Hannan Knitwears Limited

555, Rahan Ali Road, North Khaikur Road, National University, Gazipur
(23,945026N, 90,390026E)

17 October 2015

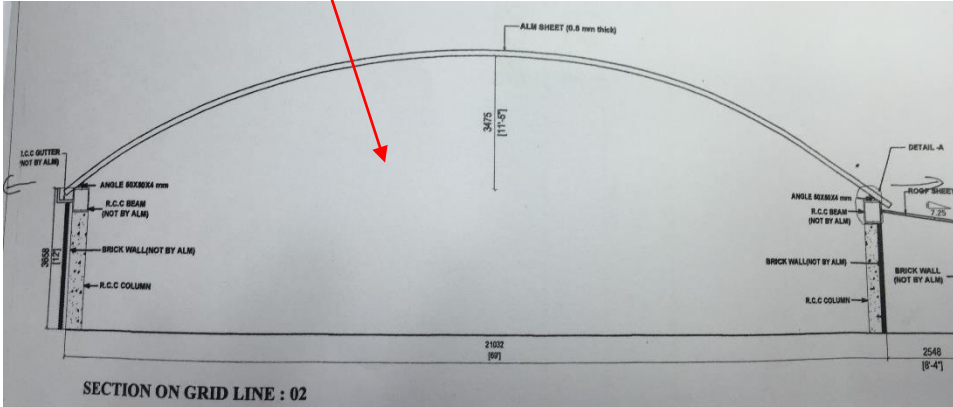
No tie in the arches (21m)

No evidence of calculations of the roof structure

0.8mm metal trapezoidal sheet

Steel Structure

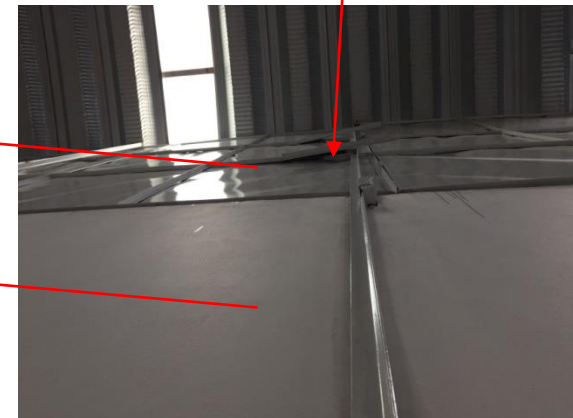
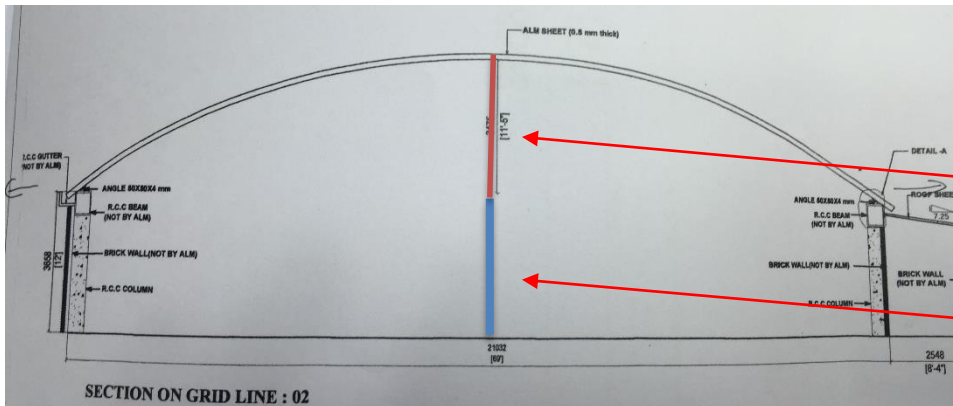
Vertical partition that seems to be touching the roof

Thickness (flanges and webs):
Main Beam (each floor) - 5mm
Secondary Beams (each floor) - 3mm
Columns (2nd and 3rd floor) - 5mm

It appears that the steel sections could be affected by lateral torsional buckling effects

Discontinuous welds in one side (continuous on the other side)

Other Observations

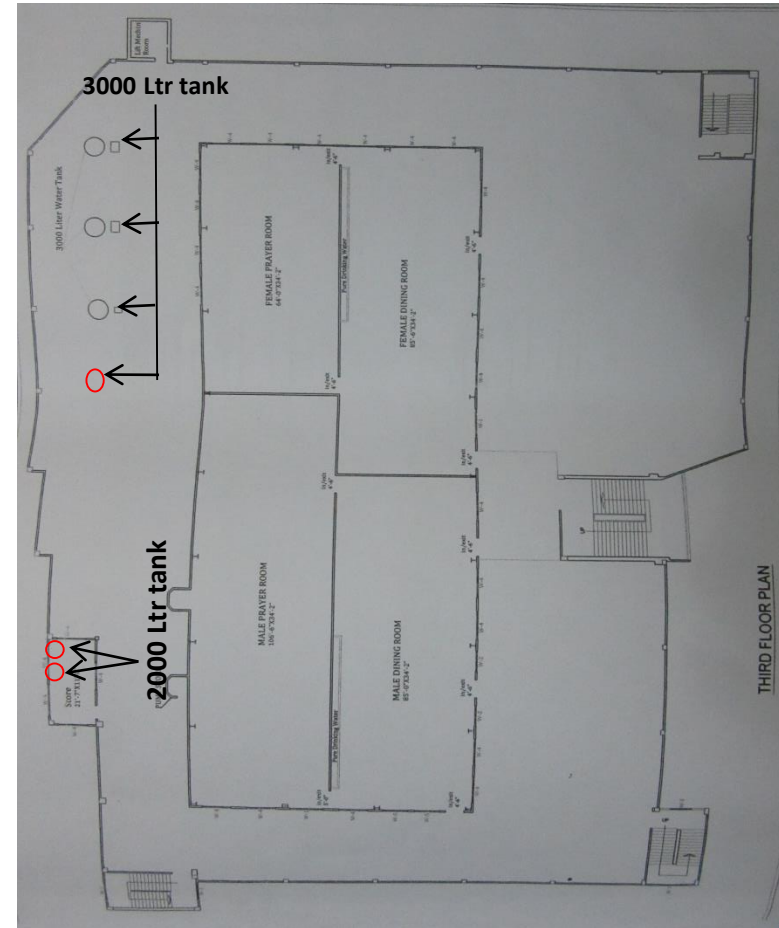
No Cross Bracing at Ground Floor

Main entrance Canopy structure

Lack of verticality of one of the Steel Columns

Base connection not well completed
